CITY OF SOUTHGATE

PLANNING COMMISSION

AGENDA

MONDAY, July 13th, 2026

UTILITY, STORM & GRADING PLAN
SUPERIOR/ALLEN APARTMENTS
RM DEVELOPMENT
PART OF THE SOUTHWEST 1/4 OF SECTION 26, T.3S., R.10E.
CITY OF SOUTHGATE WAYNE COUNTY, MICHIGAN

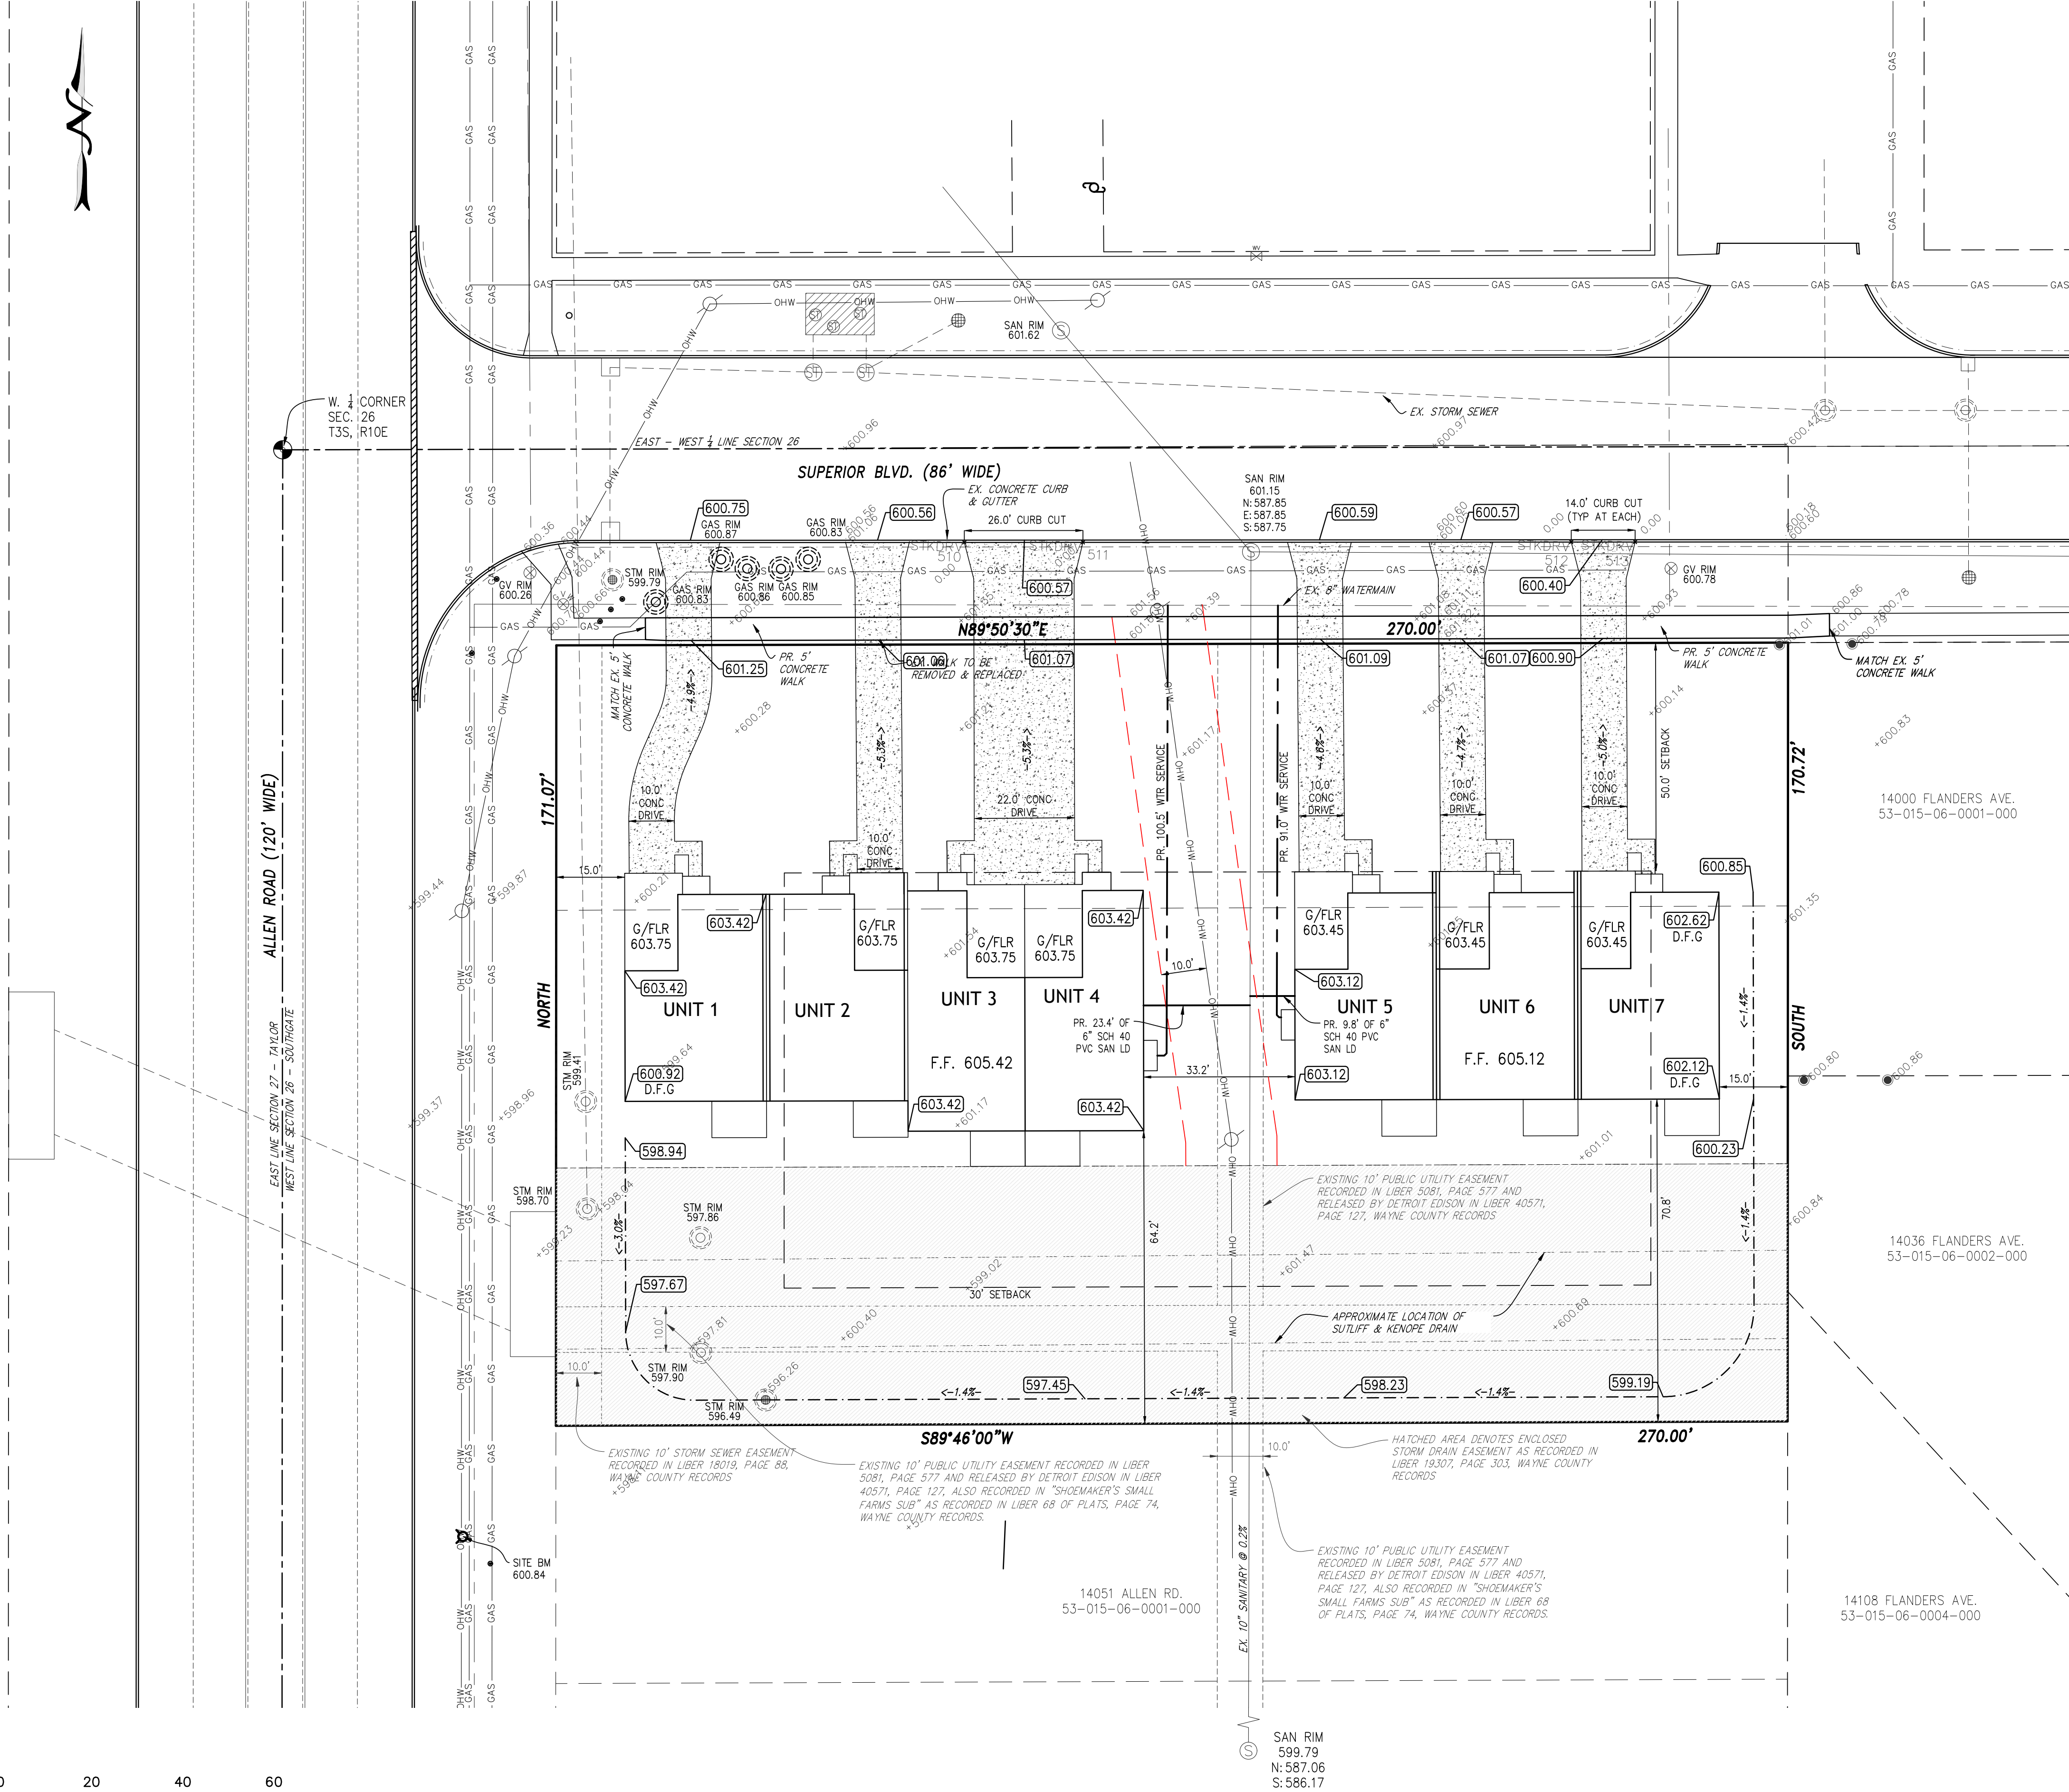
A utility plan provided on Sheet 03 shows proposed water service, existing gas service, and overhead lines. All proposed utility work is subject to approval by the City Engineer.

LANDSCAPE PLANTING PLAN

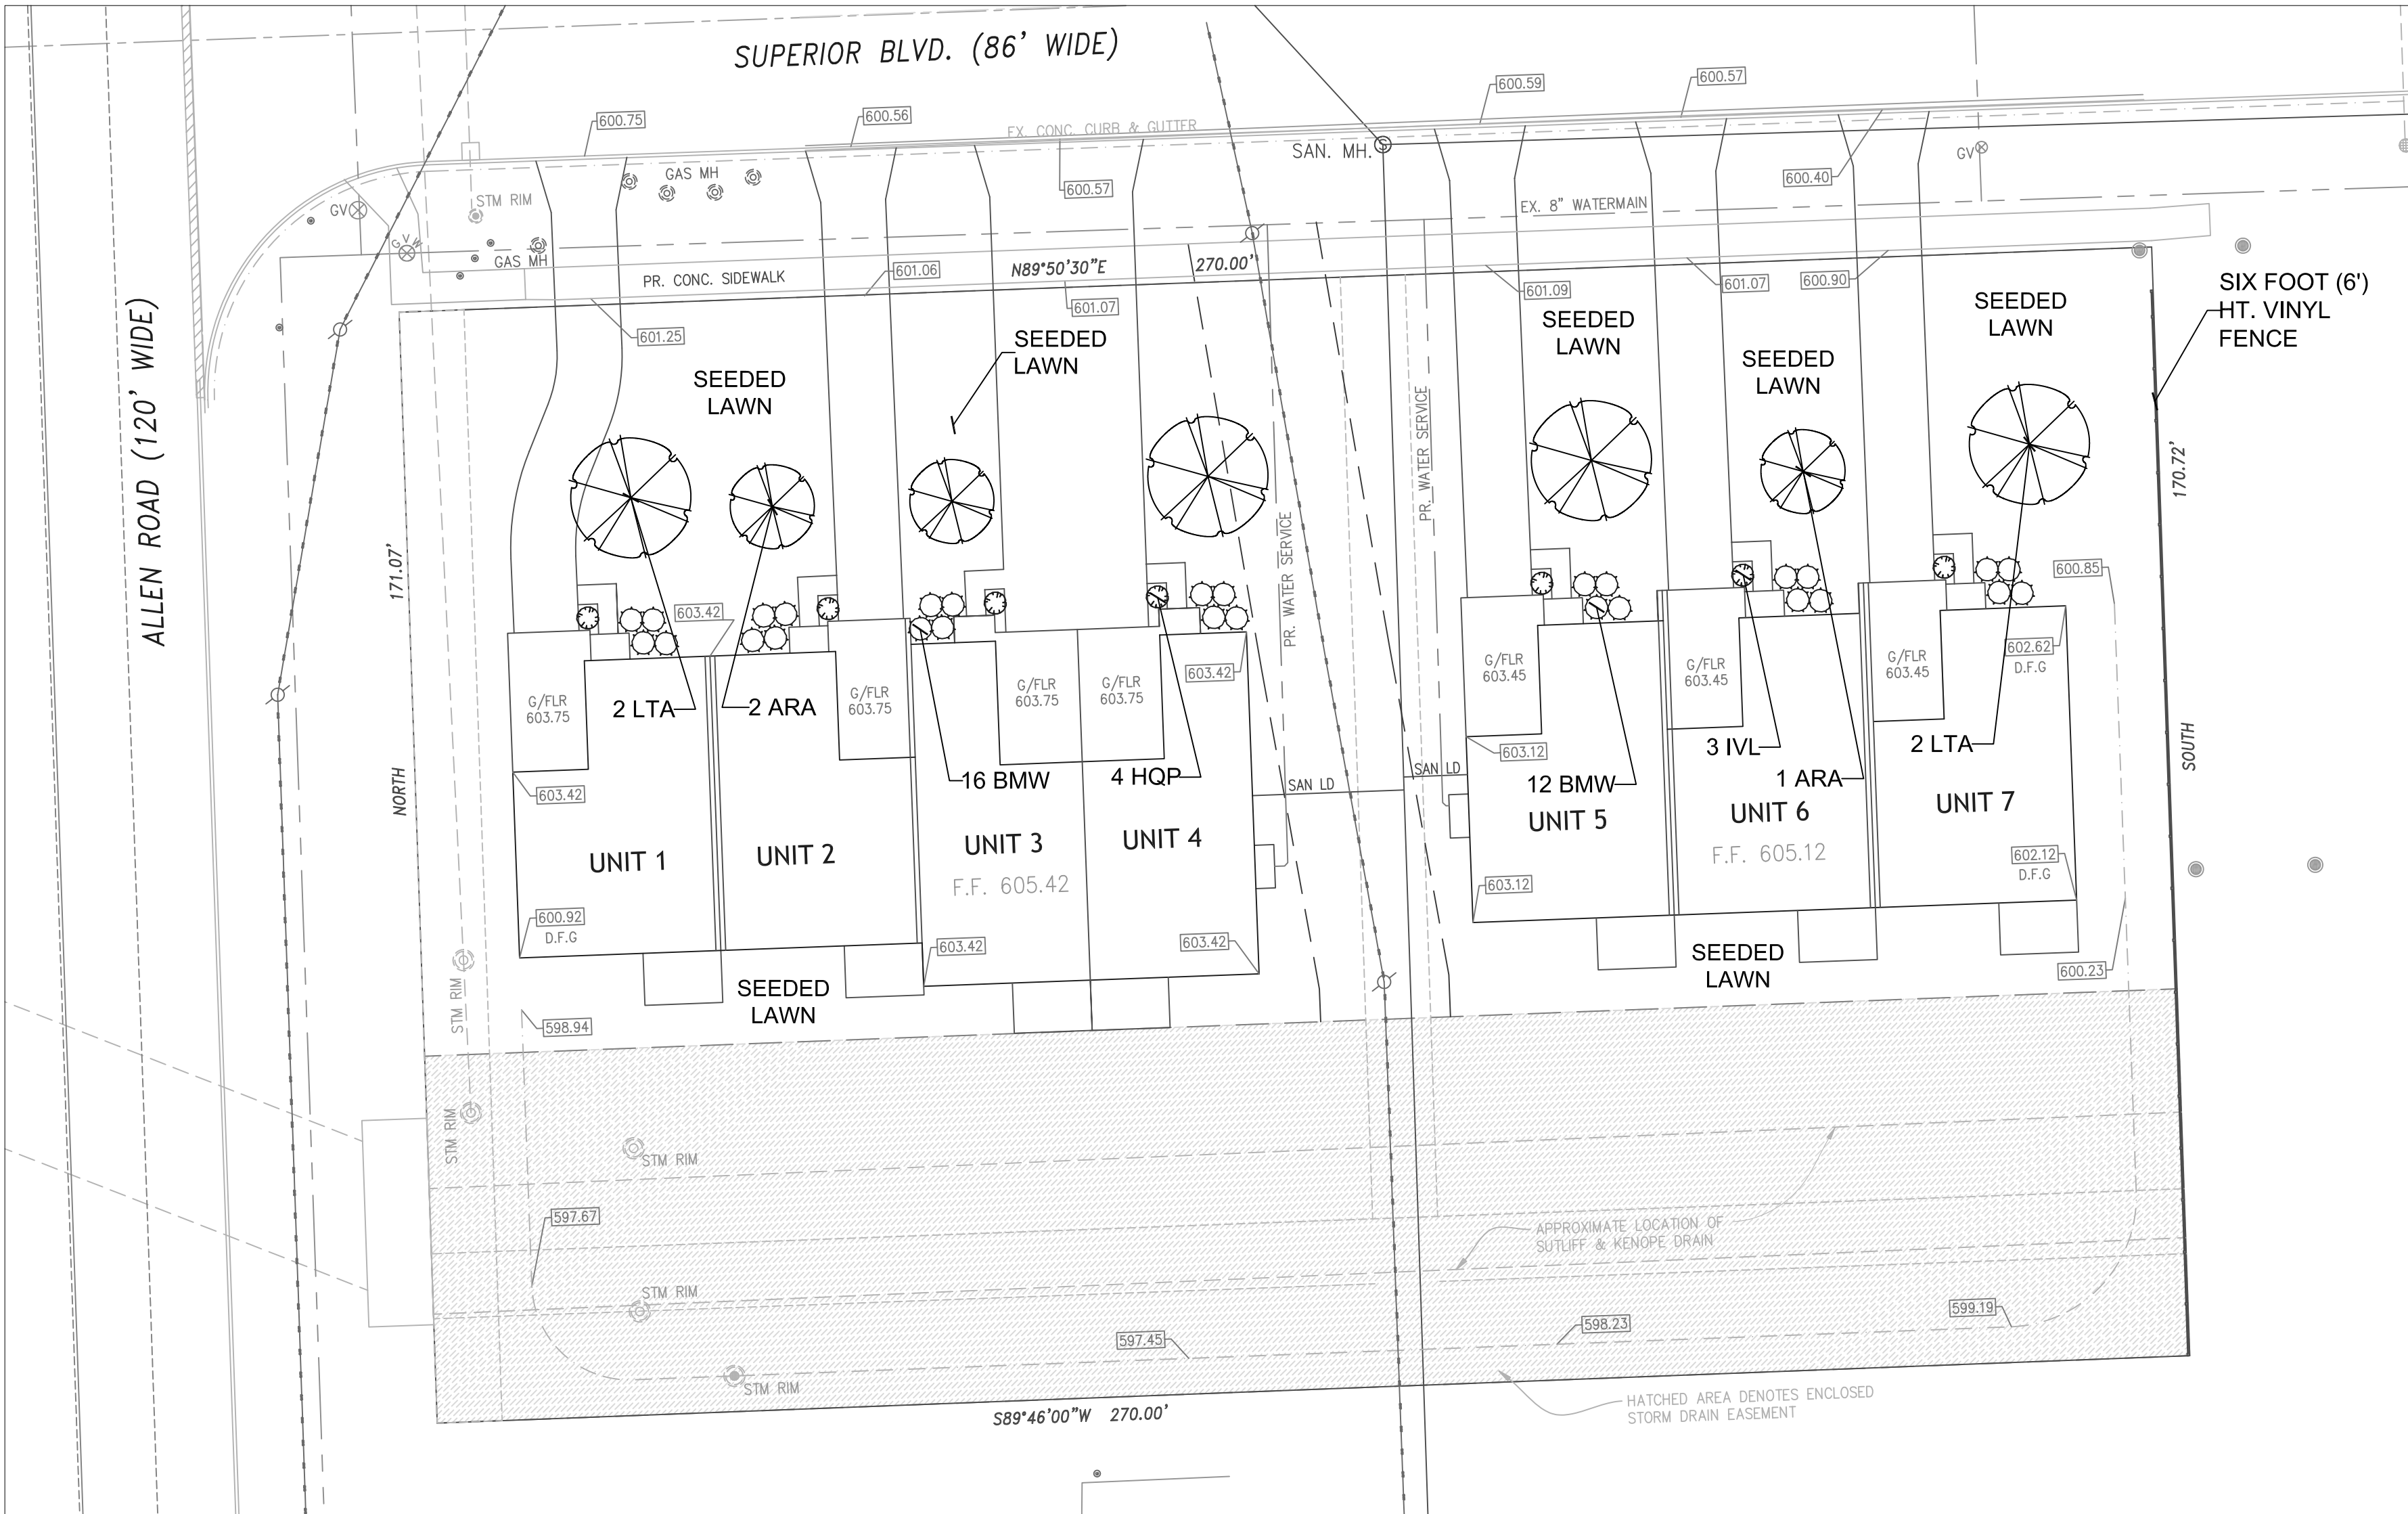
A landscape plan is provided on sheet LP-1. A six (6) foot tall vinyl fence is proposed along the eastern property line; detail drawings are required. Seven (7) deciduous trees throughout the site in addition to perennial/boxwood plantings are also proposed in the front yard of each unit.

Items to be Addressed: 1) Provide fencing details. 2) Planning Commission to consider requiring additional landscape plantings as described in this report.

UNIT # 17
UNIT # 16
UNIT # 15
Front Elevation - Building #5

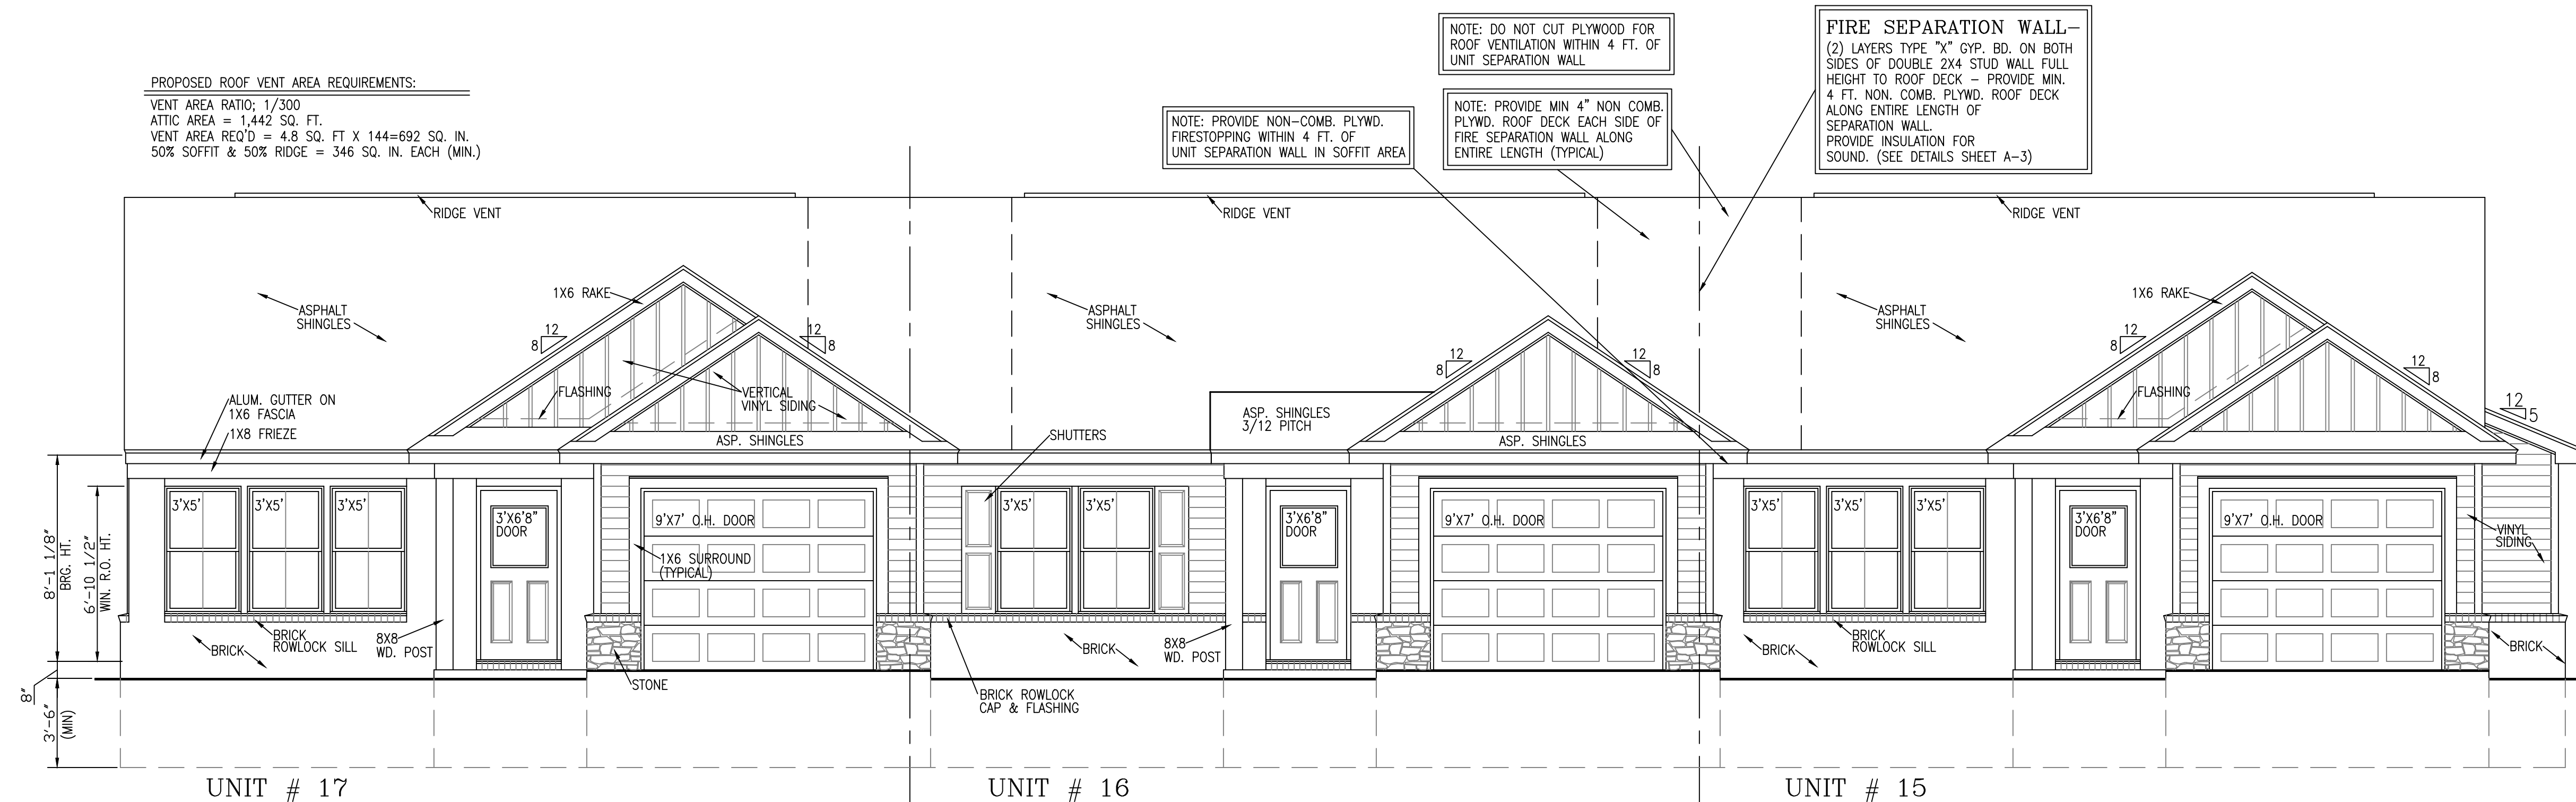
- Floor plan labels, such as on sheet A-7, mention unit numbers 15, 16, and 17. Only seven (7) units are proposed for the project. Labeling throughout the floor plans and elevations will need to be corrected to the correct unit numbers.
- The overall site plan provided on sheet 01 shows units 3 and 4 having a shared driveway. All floor plans provided show each unit with its own garage/driveway.
